**STAFF REPORT
KETCHUM PLANNING AND ZONING COMMISSION
REGULAR MEETING OF JUNE 17, 2026**

PROJECT: Brown Residence Addition

FILE NUMBER: P26-018

APPLICATION TYPE: Mountain Overlay Design Review

Figure 3: Building Height Bonus Façade Step Back

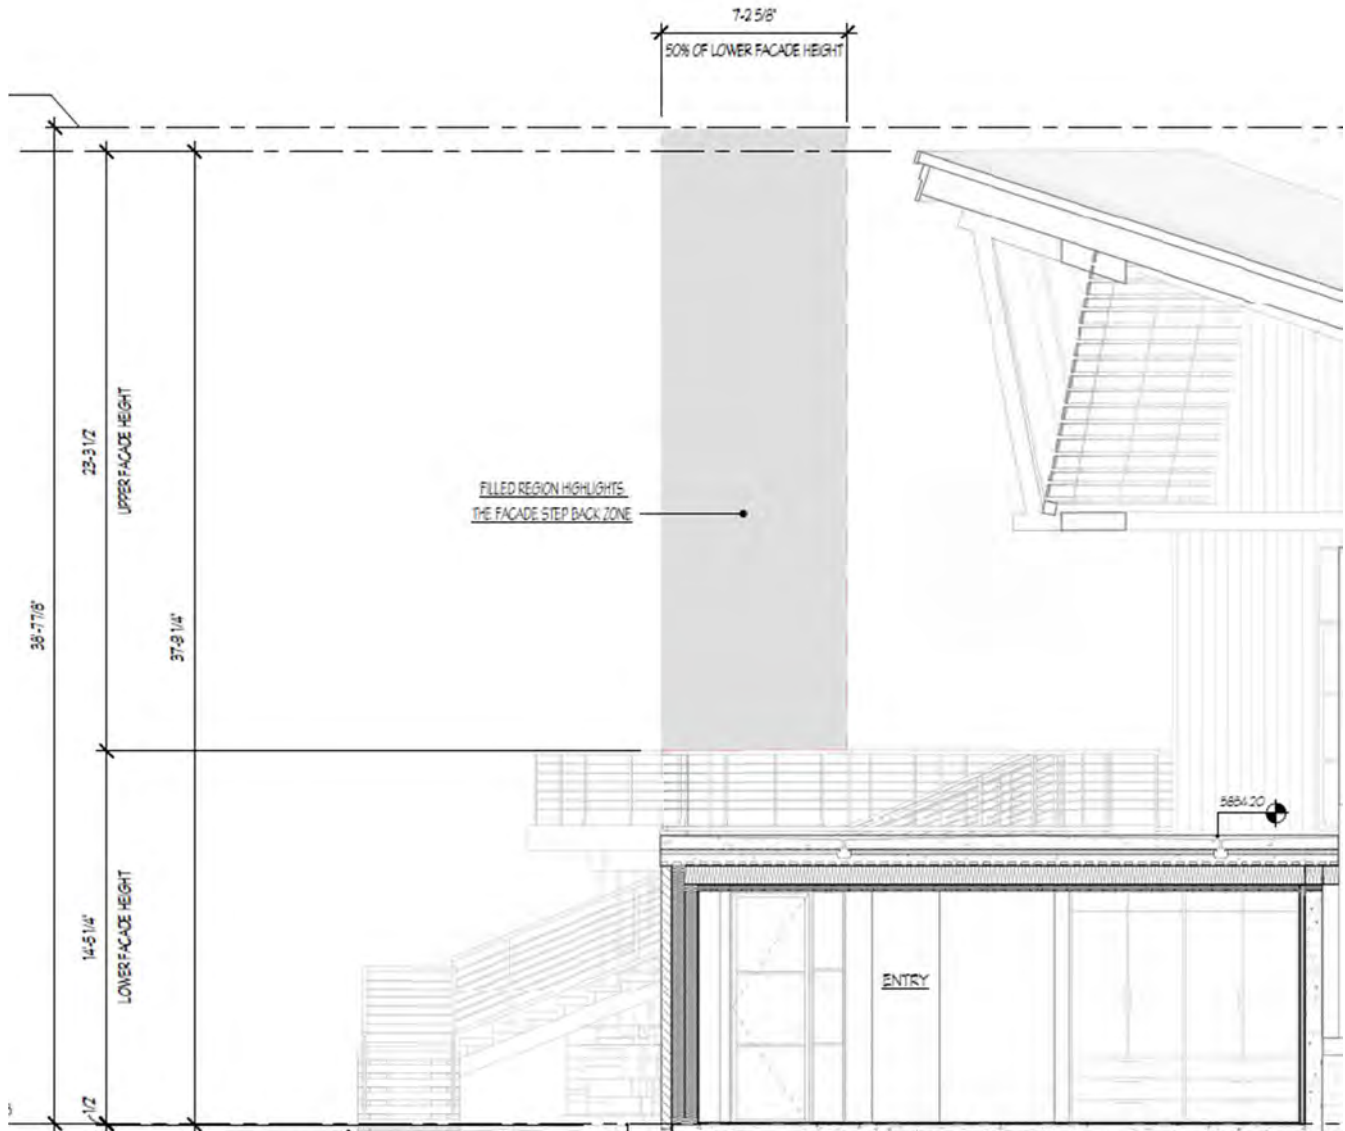
Pursuant to KMC §16.08.020, hillside properties may receive a 5’ building height bonus provided that any upper façade stepping up or down a hillside is setback a minimum of 50% of the height of the lower façade wall. The project qualifies for the 5’ hillside building height bonus because it exceeds the minimum façade setback requirement. The existing residence has a building height of 34’-8” and the proposed height is 38’-8”. On the west side of the structure, the lower façade wall has a height of 14’-5 ¼”, requiring a minimum upper façade setback of 7’-3”. Compliance with the façade setback is illustrated in Figure 3 below and on Sheet 4.00 of the project plans in Attachment A.

PROPOSED WEST BUILDING ELEVATION 2

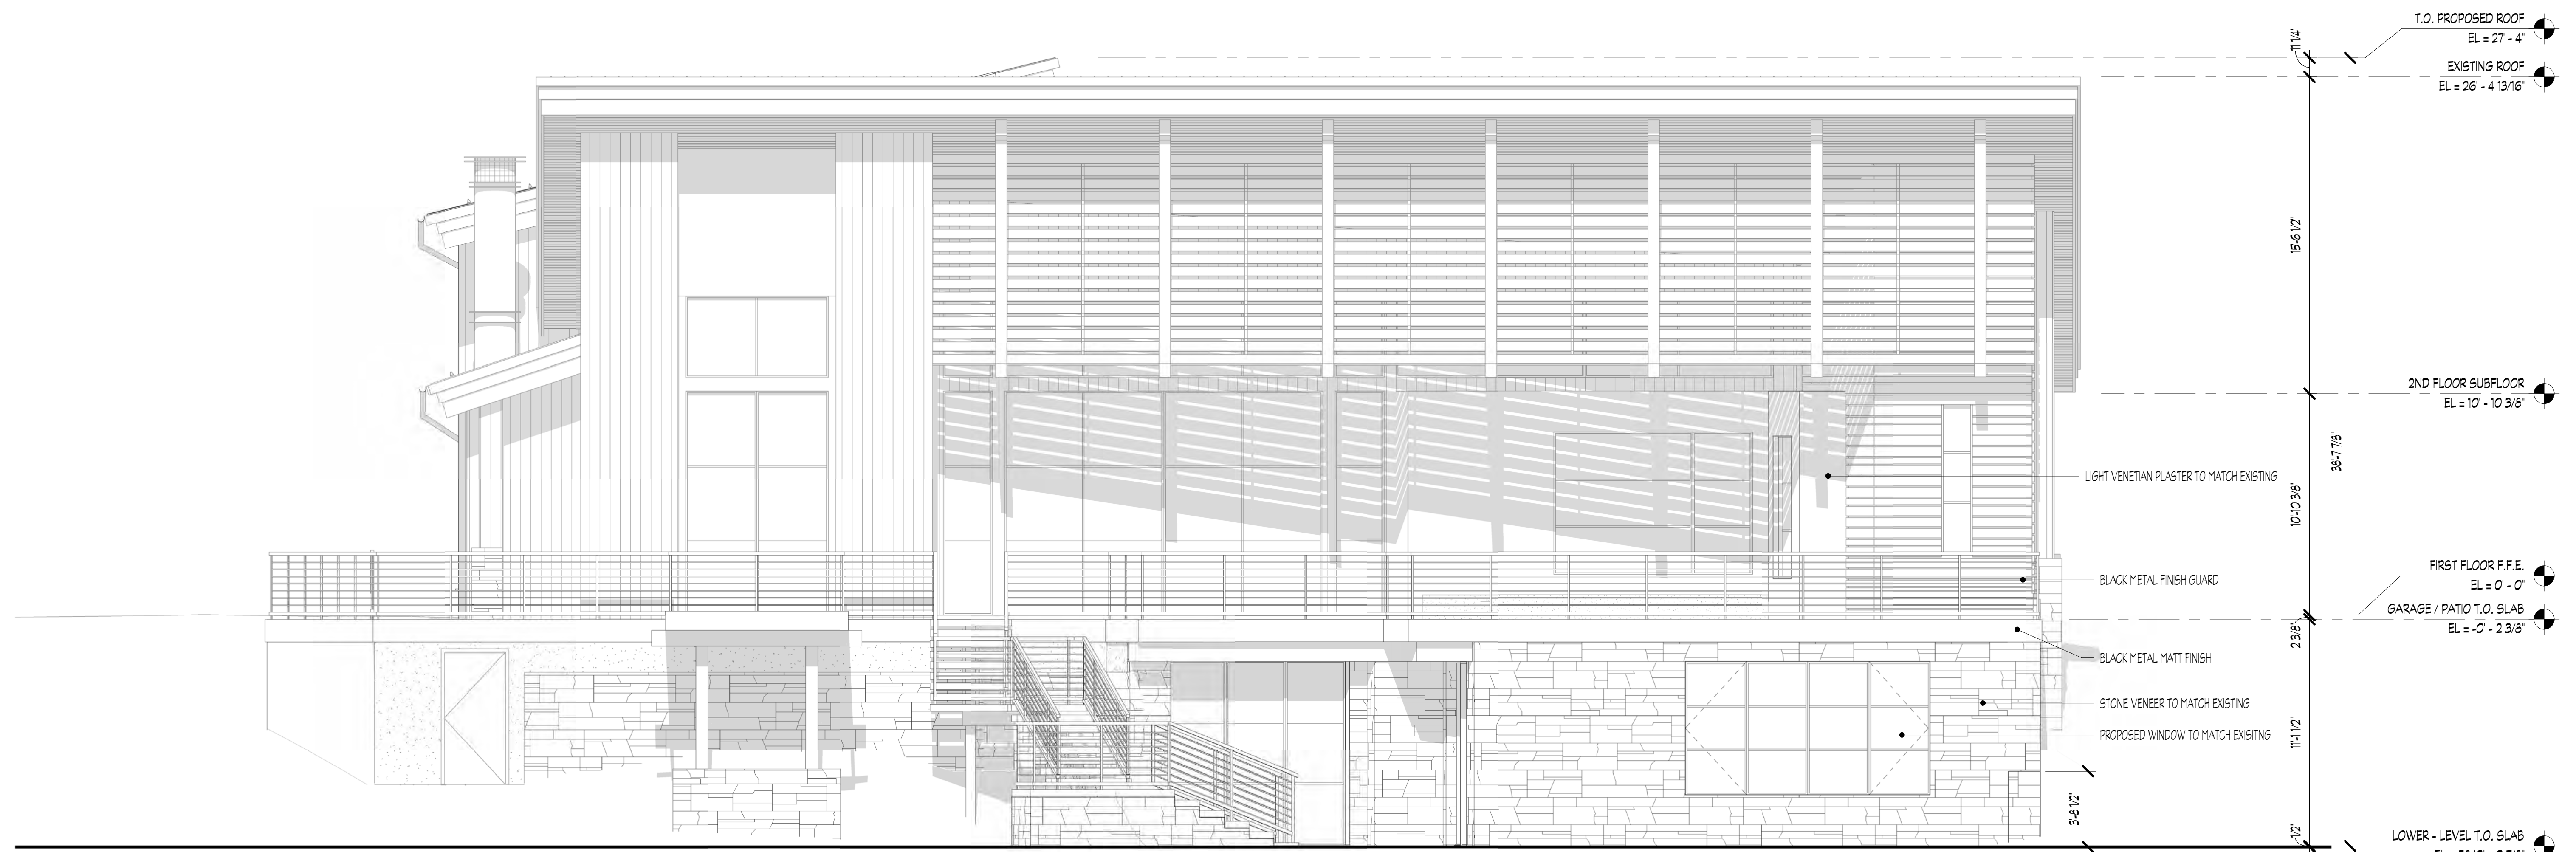
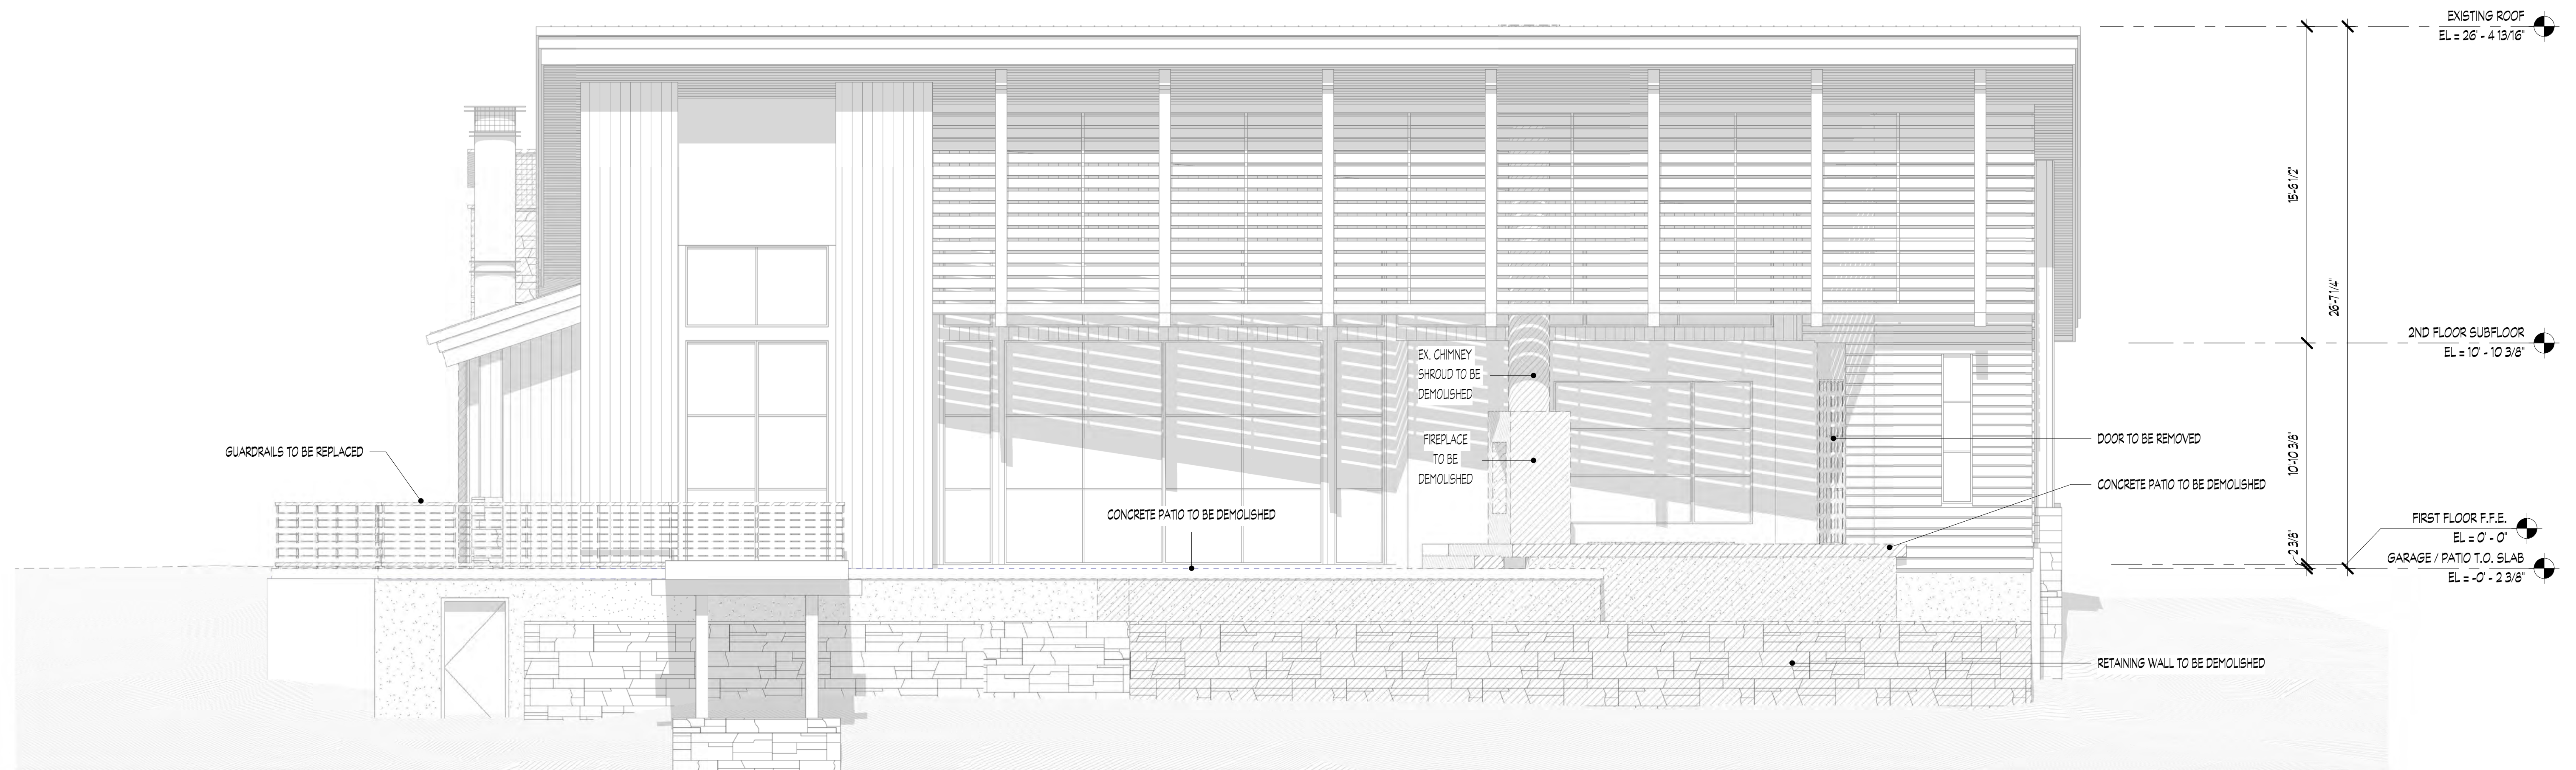
Following city department review, planning staff identified an error related to the west side setback that was discovered after the application had been noticed for a public hearing, at which point changes to the project plans could not be made. For the LR zone, the side setback requirement is 1’ for every 2’ of building height or 10’. The new building height of the structure is 38’-8”, resulting in a minimum required side setback of 19’-4”. The project proposes a new exterior stair on the west side of the structure. The stair is an appendage of the structure and is subject to setbacks due to being greater than 30” from grade. The stair is setback 19’-1 ¾” from the west side property line, which is less than the minimum required setback. Staff discussed the issue with the applicant, and they acknowledged that the stair will need to be relocated to comply with the side setback requirement. Condition of approval #2 has been added to require the applicant to revise the project plans to comply with the minimum west side setback requirement prior to building permit application submittal.

The residence also has an existing balcony on the west side of the structure that is setback 18’-3 ½” from the property line. This balcony is to be retained, and no modifications are proposed to it. The balcony’s setback becomes nonconforming with the new building height of the structure. Pursuant to KMC §16.01.050, a nonconforming building or structure may not be enlarged, expanded, or removed and reconstructed. Because the balcony is existing and is not increasing in size or being reconstructed, it can remain in its current location even though it’s not compliant with the new minimum required side setback of 19’-4”.

2. Prior to issuance of a building permit, the applicant shall submit revised plans demonstrating compliance with the minimum required west side setback. The exterior stair on the west elevation shall be relocated or otherwise modified as necessary to achieve compliance with the minimum side setback requirement of 19'-4", subject to Planning staff review and approval.
